# Technical Service Bulletin

<b>Subject:</b>  <b>GRINDING NOISE FROM MANUAL TRANSMISSION IN 2ND AND/OR 3RD GEAR AND/OR HARD TO SHIFT INTO 2ND AND/OR 3RD GEAR</b>	<b>Bulletin No.:</b> 05-001/17
	<b>Last Issued:</b> 10/09/2017

2016-2017 MX-5 vehicles (soft top only) with VINs lower than JM1ND\*\*\*\*H\*121392 (produced before September 6, 2016)

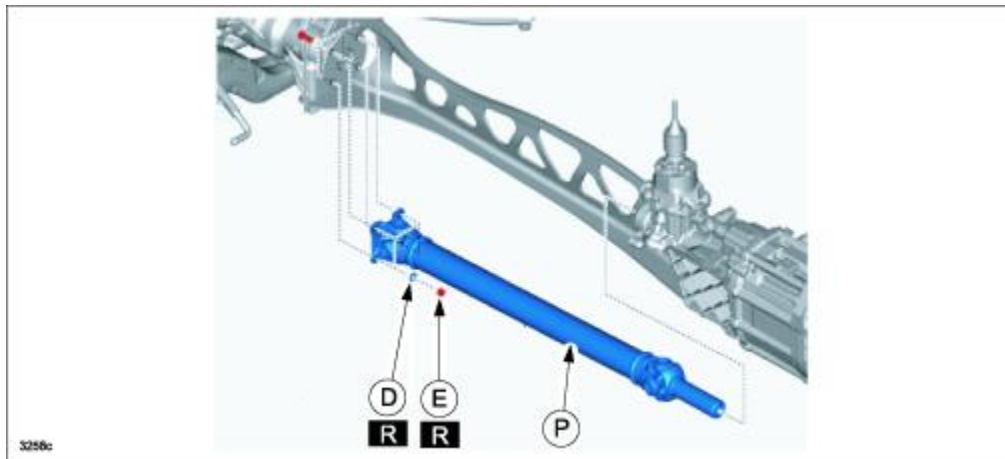
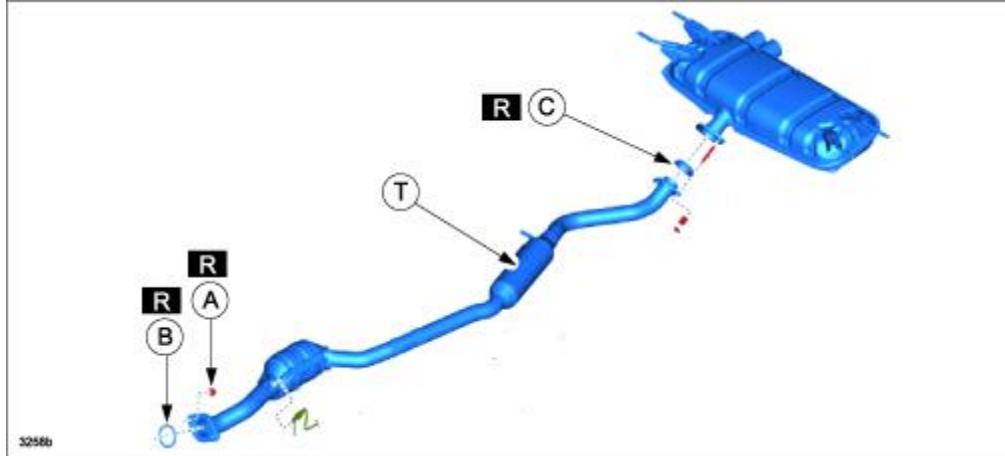
This may be caused by damage to 2nd and/or 3rd gears if the vehicle was driven with rapid acceleration and deceleration using frequent shift changes. To eliminate this concern, the configuration of the 2nd and 3rd gears has been changed to increase the rigidity.

**NOTE:** Transmissions with the serial No. "6TJ0701679" or higher are modified.

1. Verify the customer concern.
2. Replace the complete manual transmission with a modified one according to the instructions on MGSS (TRANSMISSION REMOVAL/INSTALLATION [M66M-D]).
3. Verify the repair.
